Engineering Change Notification

This notice is to inform you of a change to the following LCD products:

NHD-0216K1Z-FS(RGB)-FBW_rev1
NHD-0216K1Z-NS(RGB)-FBW_rev1

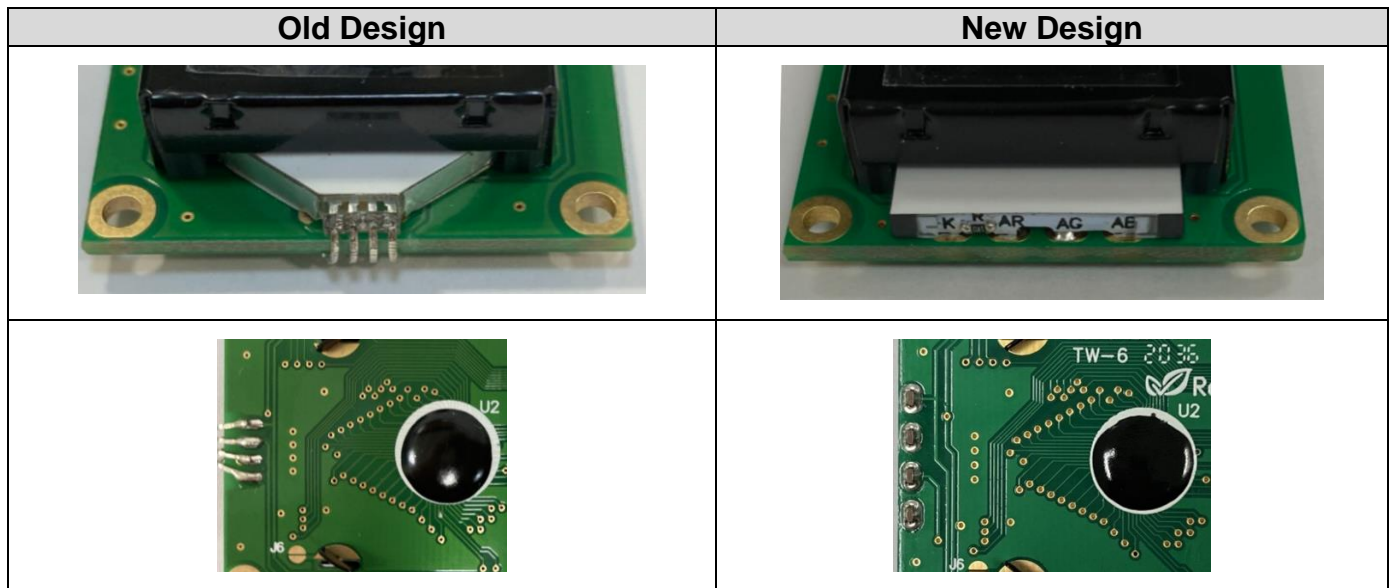
The backlight has been redesigned to improve the connection method for anode and cathode. Old backlight design used thru-hole LEDs with leads that wrapped around the PCB. New backlight design uses surface-mount LEDs, which are connected to the PCB using thru-hole leads.
